## City of Mississauga Department Comments

Date Finalized: 2023-04-26 File(s): A93.23

Property Address: 1407 Stavebank Road

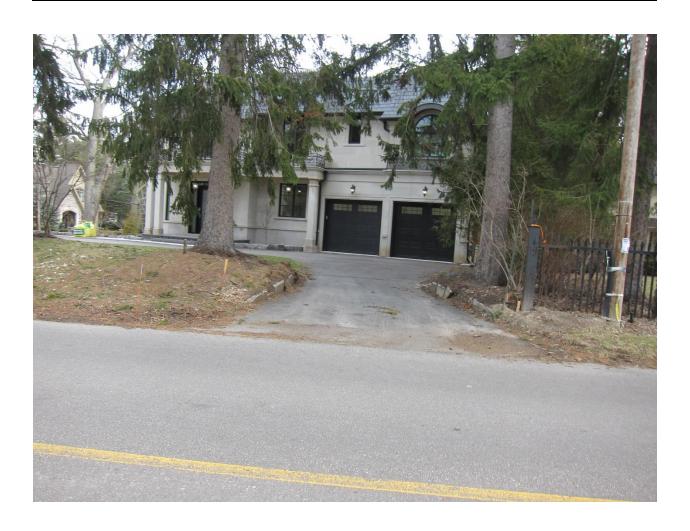
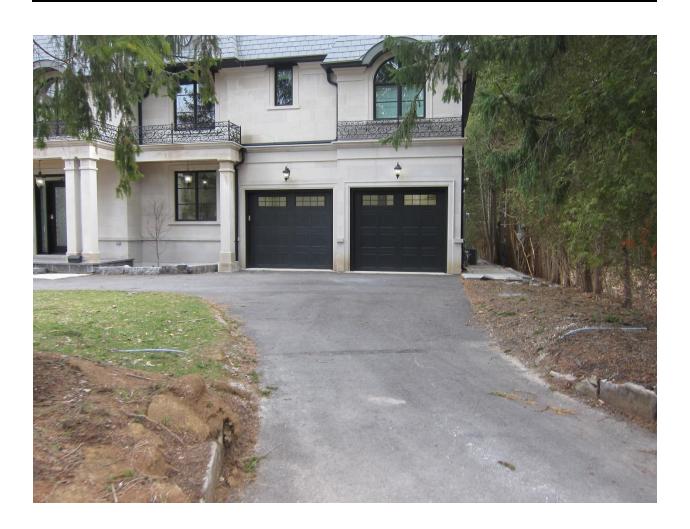
Enclosed for Committees easy reference are photos of the existing driveway. We have no drainage related concerns.
